RS-12-006

Braidwood Station, Units 1 and 2
Facility Operating License Nos. NPF-72 and NPF-77
NRC Docket Nos. STN 50-456 and STN-50-457

Byron Station, Units 1 and 2
Facility Operating License Nos. NPF-37 and NPF-66
NRC Docket Nos. STN 50-454 and STN 50-455

Subject: License Amendment Request for the use of an Auxiliary Feedwater Cross-tie Between Units

**FIGURE:
AUXILIARY FEEDWATER SYSTEM**

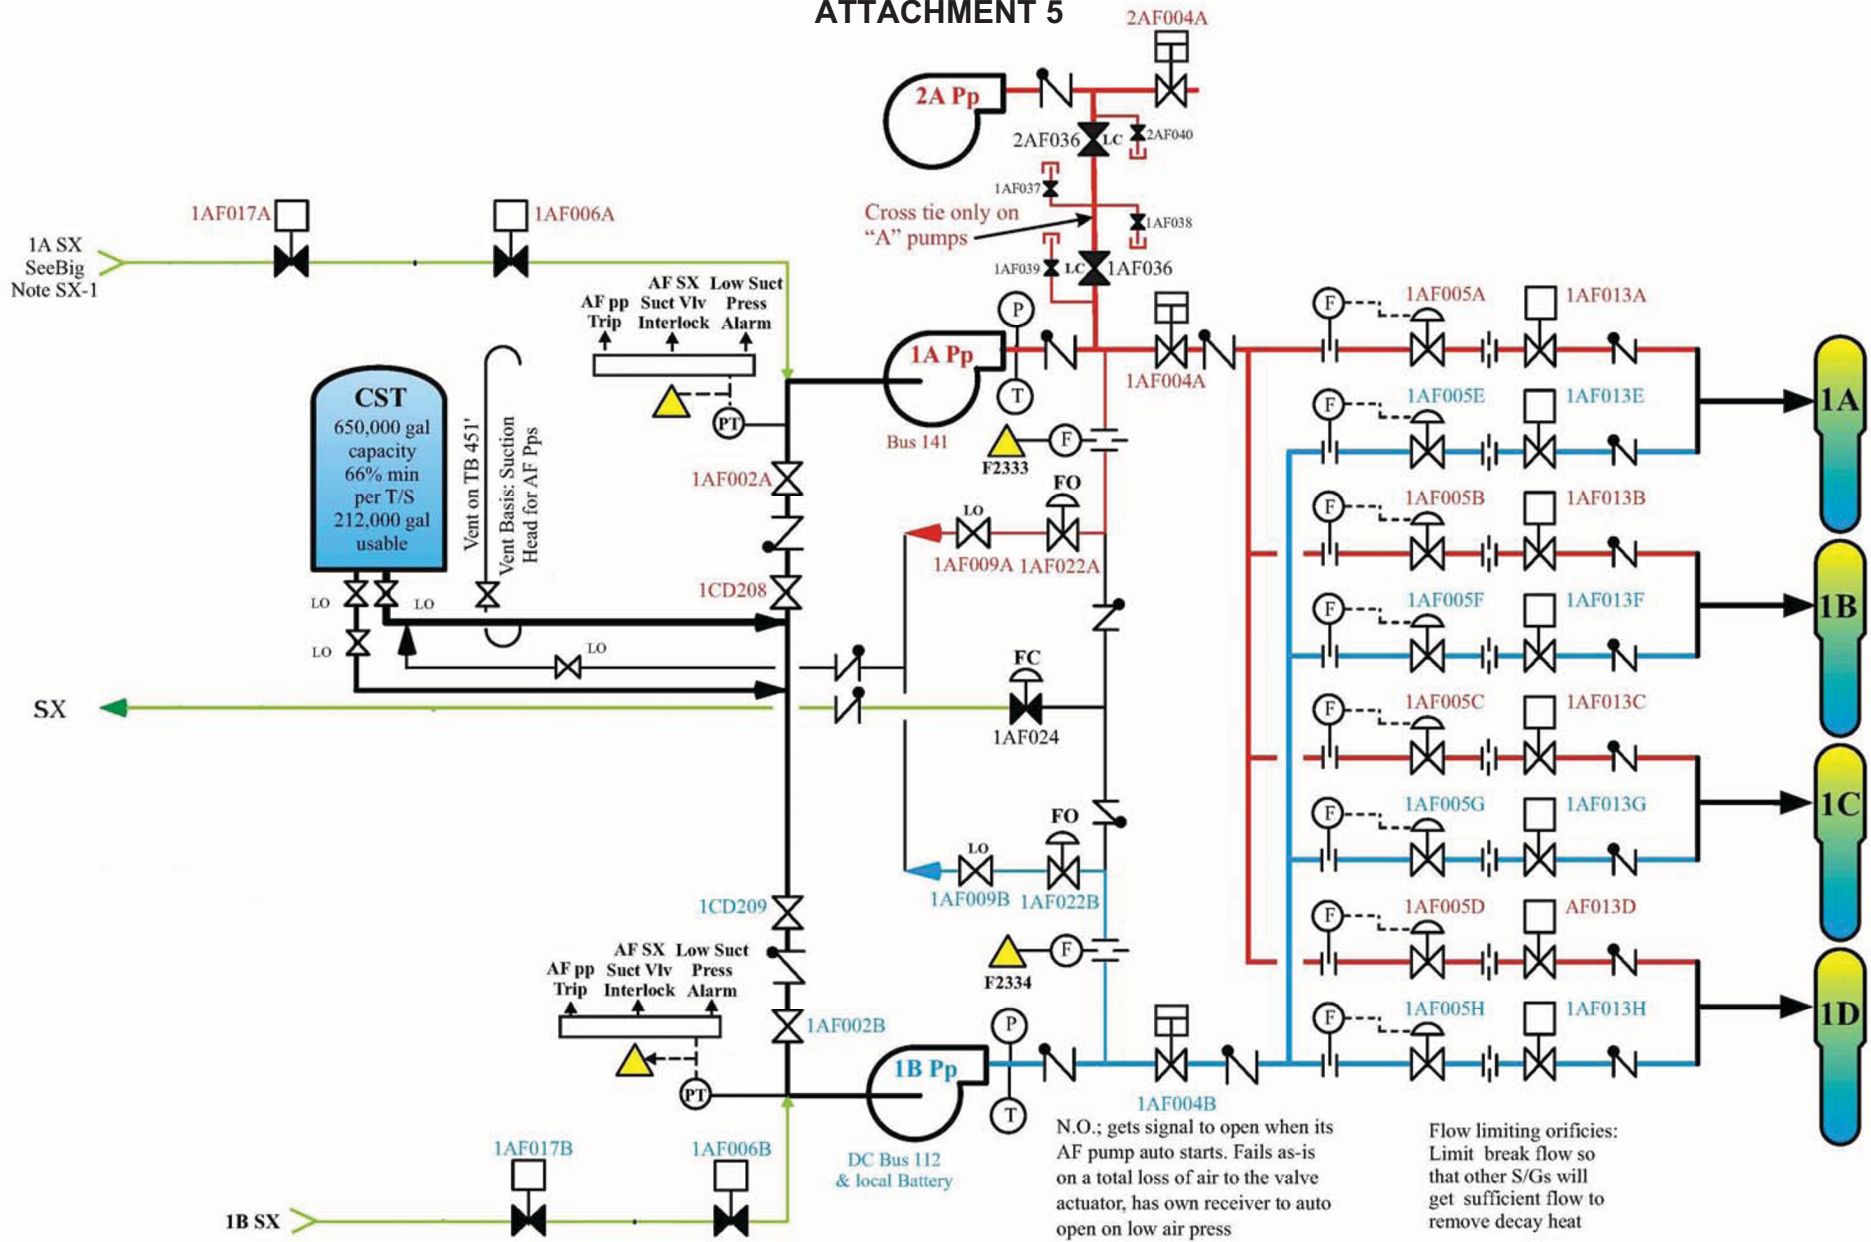
Example actions that use the AF Train A unit cross-tie at Braidwood Station, Unit 1, are provided in Attachment 3 and are typical for both units at each station. A figure showing the AF system with the AF Train A unit cross-tie piping and components is provided in Attachment 5.

EGC installed the AF Train A unit cross-tie piping modifications in 2009 and 2010. The new piping modification provides the capability to tie the AF Train A pump discharge from one unit to the other unit, between two isolation valves. The AF Train A unit cross-tie piping is 6-inch diameter piping that is equivalent to the existing AF Train A pump discharge piping diameter. A simplified figure of the AF system is provided in Attachment 5. The AF Train A unit cross-tie line is located at the discharge of both unit's AF motor-driven pumps, 1AF01PA (Unit 1) and 2AF01PA (Unit 2), in the Auxiliary Building. The AF Train A unit cross-tie is normally isolated with the two manual closed and locked isolation valves 1AF036 (Unit 1) and 2AF036 (Unit 2). AF Train A unit cross-tie piping is also maintained filled and vented between these two manual isolation valves.
